UNITED STATES PATENT AND TRADEMARK OFFICE

10/776,346

Office Action Summary	Application No. 10/776,346	Applicant(s) SEIVER ET AL.	
	Examiner Michael J. Early	Art Unit 3744

DETAILED ACTION

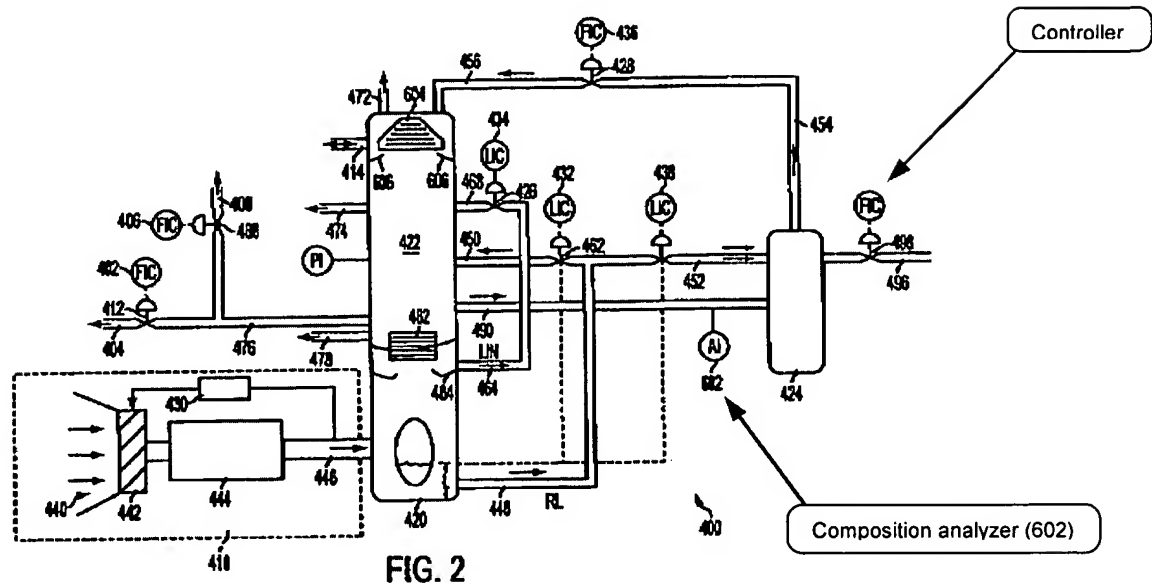
Seiver et al. disclose:

- an air input subsystem (410 – air input subsystem);
- at least one distillation column (420 – high pressure cryogenic distillation column);
- a processed air stream (446 – cool, dry, high pressure air);
- a raw argon stream (490 – stream);
- the at least one distillation column is located downstream from the air input system (as seen in Figure 2);
- a crude argon column (424 – crude argon column);
- a crude argon stream (496 – argon-rich flow);

- a controller (as seen in the illustration of Figure 2 below).

However, Seiver et al. do not expressly disclose:

- details related to the controller;
- details related to the composition and concentration of the crude argon stream.

Seiver et al. further disclose a composition analyzer ("AI") (602) that is capable of monitoring the content or purity of argon as it passes through the system (see col. 6, lines 8-13; the illustration of Figure 2 above).

Therefore, it would have been obvious to one of ordinary skill in the art at the time of the invention to modify the existing system of Seiver et al. by incorporating a composition analyzer within the system's controller, so that less error will be associated with monitoring and regulating the produced argon-rich flow (496).
